Meeting: 8/20/2025
Applicant: Amy Sherrill Benefield Richters
Owner: Break One LLC
Project: 319 S. Gay St.

Level II Major Alteration of an Existing Building/Structure

DESIGN REVIEW BOARD	8-A-25-DT		Petitioner: Amy Sherrill Benefield Richters
	APPLICATION FOR CERTIFICATE OF APPROPRIATENESS		
		319 S. Gay St. Level 2: Major alteration of an existing building/structure	
Original Print Date: 8/12/2025 Revised:			
Knoxville/Knox County Planning · Design Review Board		 Feet

1 SOUTH ELEVATION - WALL STREET - DRB REVIEW
DRB-02 1/16" = 1'-0"

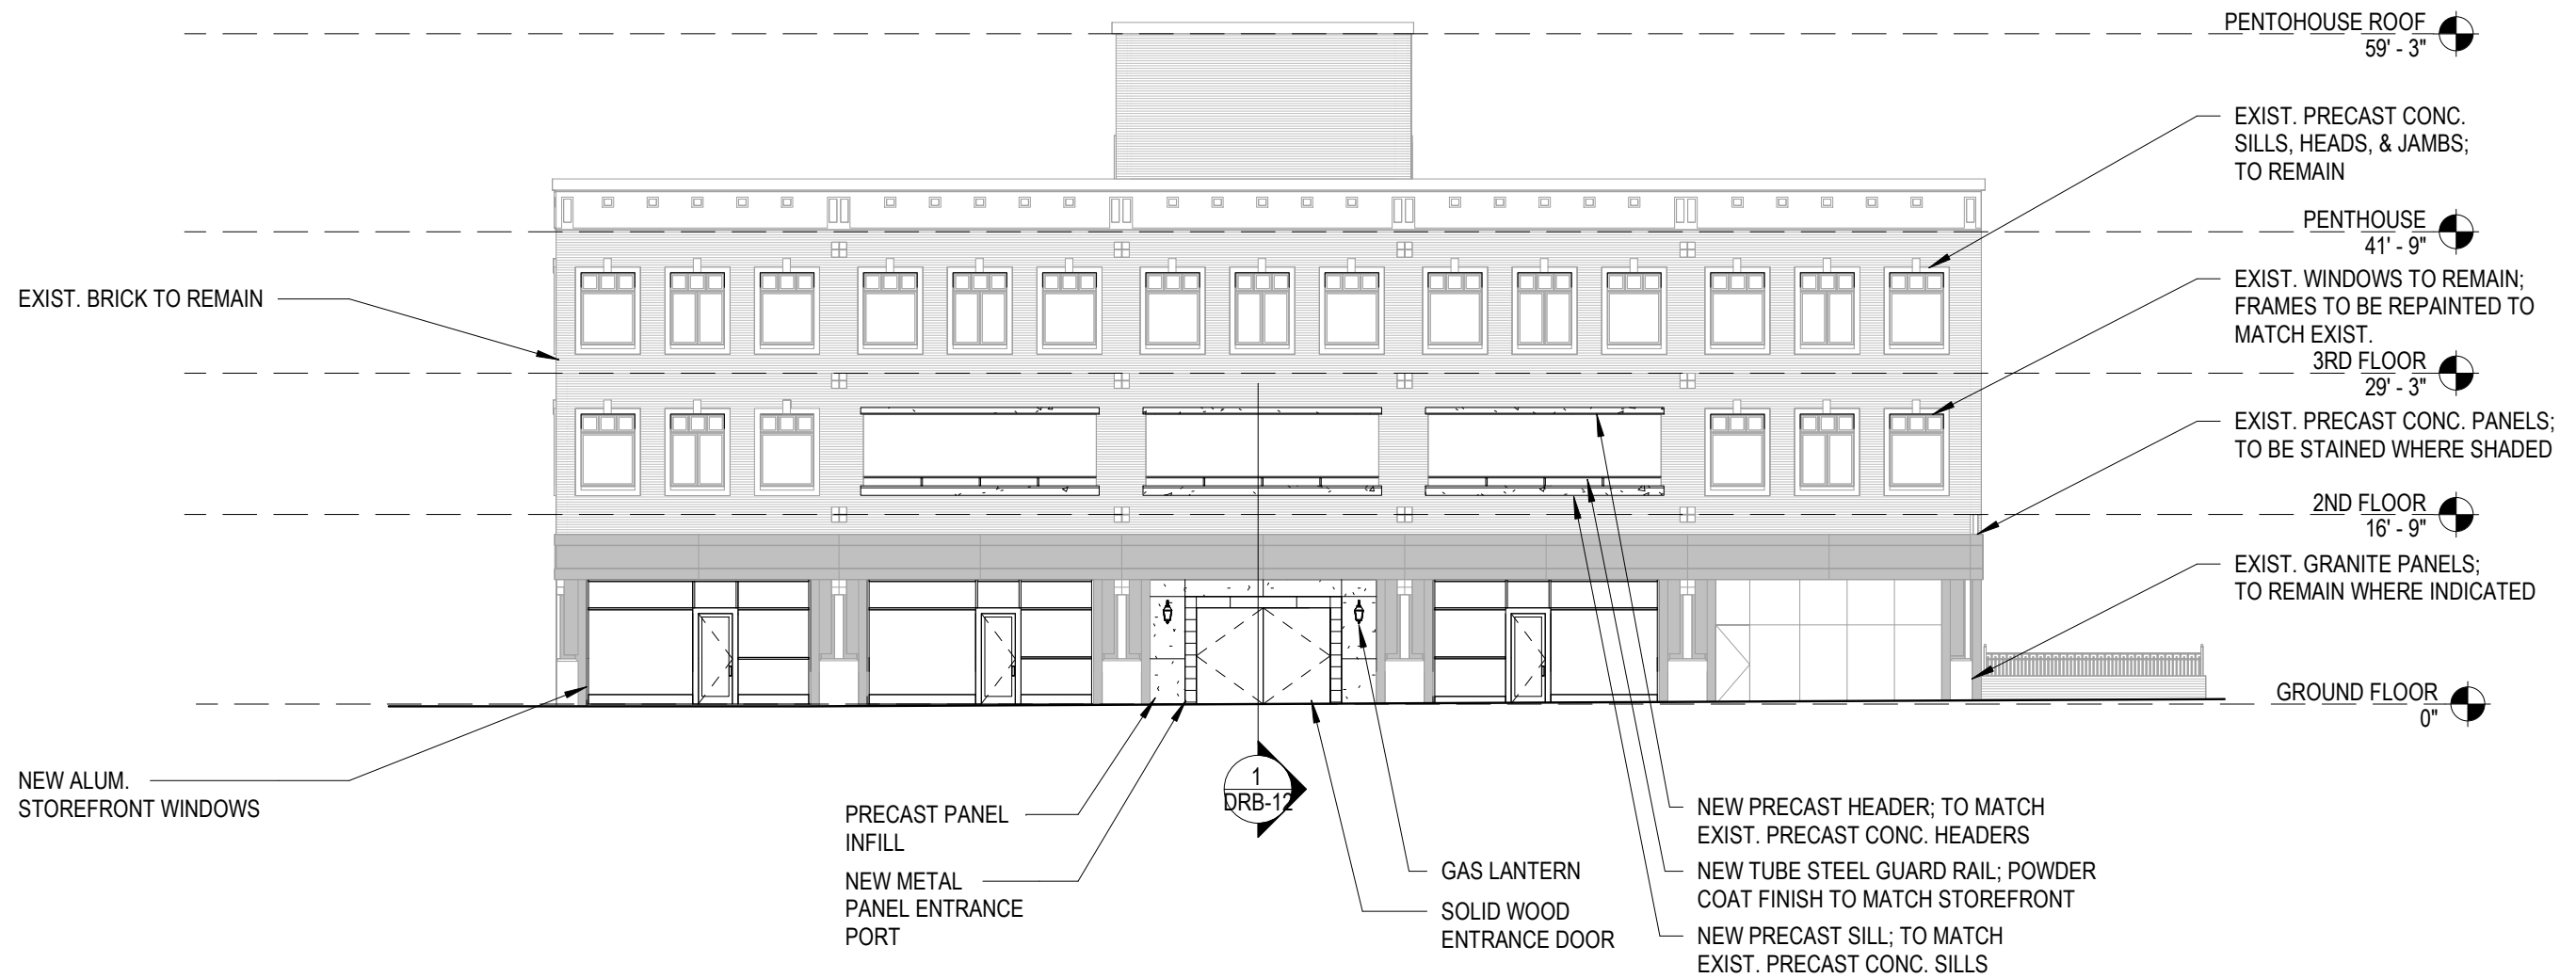
The window installation and replacements create a "largely consistent rhythm" that is recommended by the guidelines. The proposed double-hung windows in place of the existing windows on the Wall Street elevation will retain the concrete sills and lintels. The new windows on the Strong Street elevation will not have transom windows or a header capstone, but the use of matching header and sills proposes to create a cohesive look.

1 EAST ELEVATION - GAY STREET - DRB REVIEW
DRB-04 1/16" = 1'-0"

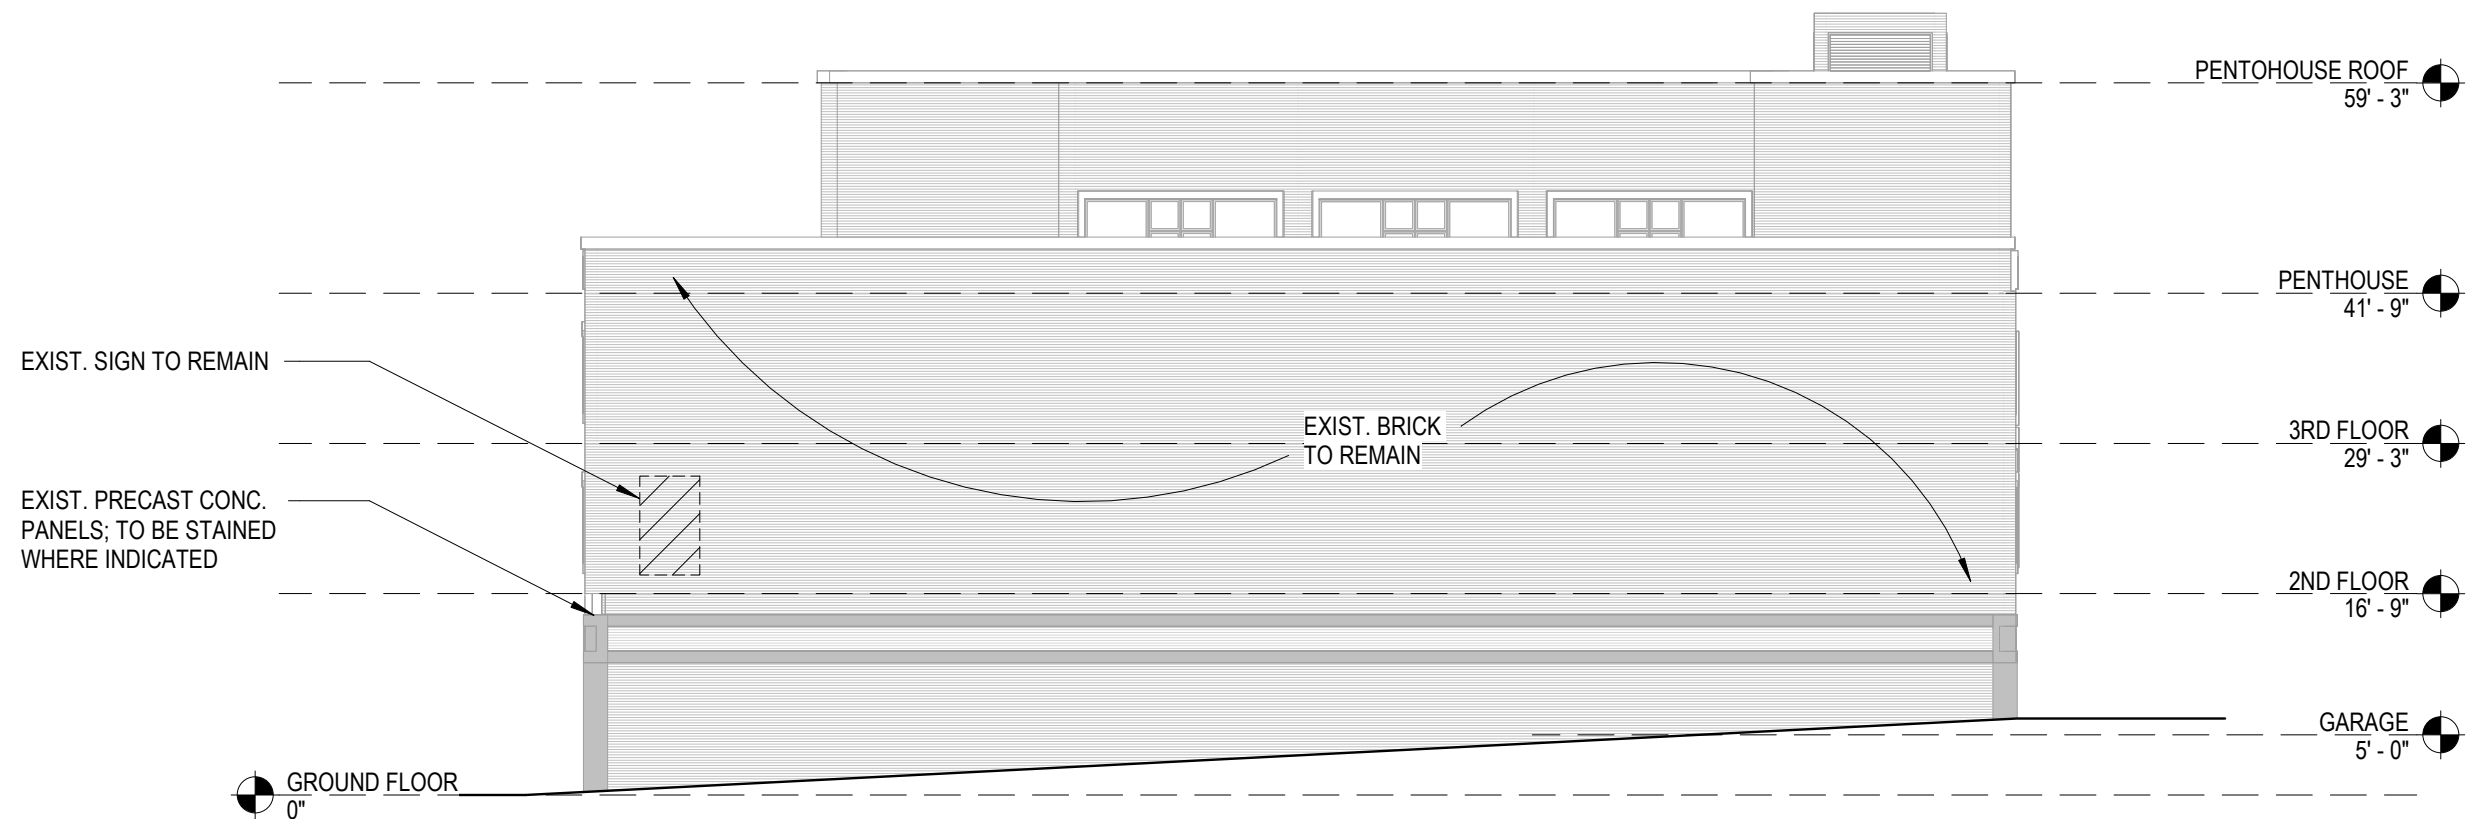
The renovation of storefronts on the first story will enhance pedestrian interest and engagement in the site. However, proposed modifications to two bays of storefront will result in the creation of some new blank wall sections and solid wood doors. This is inconsistent with the guidelines' recommendation for "avoid blank walls along street-facing elevations" and "enhance pedestrian interest in commercial and office buildings by creating a largely transparent and consistent rhythm of entrances and windows."

The removal of nine second-story windows on the Gay Street elevation should be discussed by the board. The proposed renovations have no conflicts with the design guidelines. The patios have a depth of 19'-4", so the sliding doors that opens to the patios will not be visible from the sidewalks in front of the building. They can create a visual interest for the pedestrian if they are activated with seating, planting, or lighting.

- 1) All windows at pedestrian level to be clear.
- 2) Replacing the proposed wooden doors on the storefronts with glass doors. Revised drawings shall be submitted to Planning staff for review and approval.
